GEOLOGY AND SOILS REPORT APPROVAL LETTER

LOG # 118383
SOILS/GEOLOGY FILE - 2

TRACT: Wolfskill Orchard (MR 30-9/13) / S. P. R. Co's Arcade Depot Grounds (DM 630-191)
BLOCK: 13 / --
LOT(S): -- (VAC ORD 29227) (Arbs. 168 & 601), 1-8, 9 (Arbs. 1 & 2), 10-25, & FR 26-FR 28 / PT Unnumbered LT (Arb. 171)
LOCATION: 400-464 S. Central Avenue (South Site)

CURRENT REFERENCE	REPORT	DATE OF	
<u>REPORT/LETTER(S)</u>	<u>No.</u>	<u>DOCUMENT</u>	<u>PREPARED BY</u>
Geology/Soils Report	W1041-06-02	09/13/2021	Geocon West, Inc.

FIG. 2A

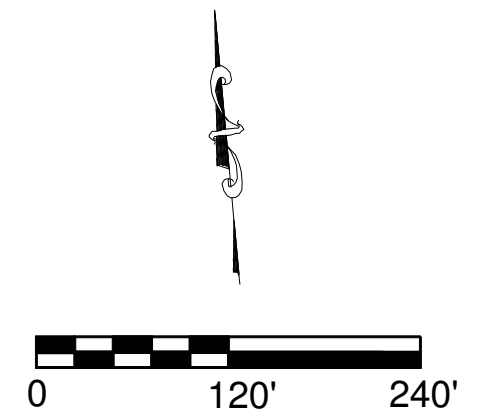
40. The infiltration facility design and construction shall comply with the minimum requirements specified in the Information Bulletin P/BC 2020-118.
41. The infiltration system shall be constructed at the location of borings B-3 and B-4 shown on the drawing attached to the current report.
